CERTIFICATE OF APPROPRIATENESS

Applicant: Sarah Hannah, Four Square Design Studio, agent for Sarah Abare, owner.

Property: 1233 Rutland Street, lot 4, block 183, Houston Heights Subdivision. The property consists of a one-story single-family residence situated 6,600 square foot (50' x 132') interior lot.

Proposal: Alteration – Addition

NORTH SIDE ELEVATION
EXISTING

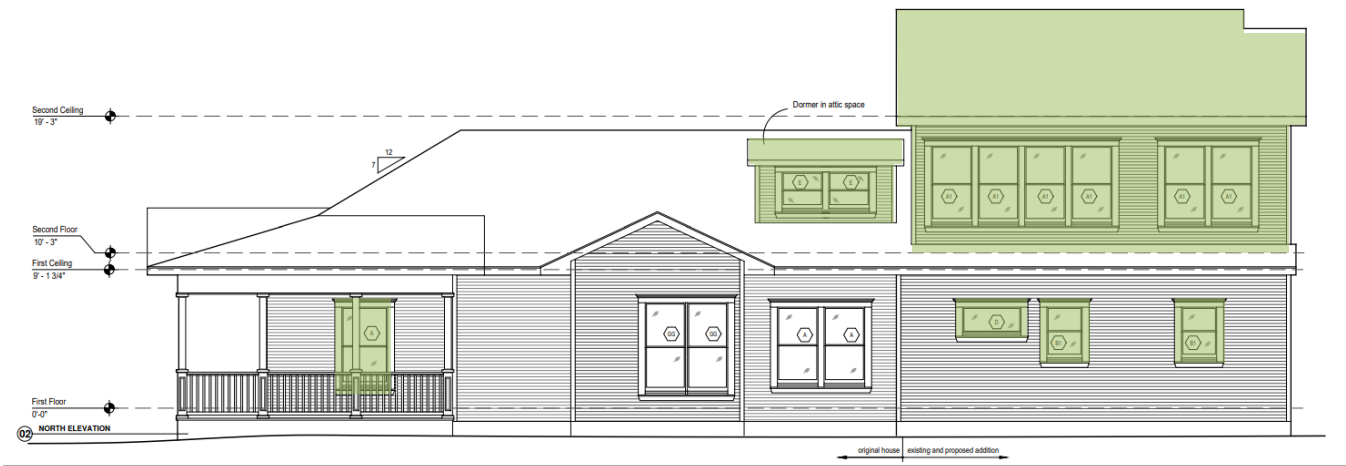
Recommendation: Approval with conditions: that the north facing window in the front room can't be opened until staff verifies during construction that there is proof of that window opening's existence.
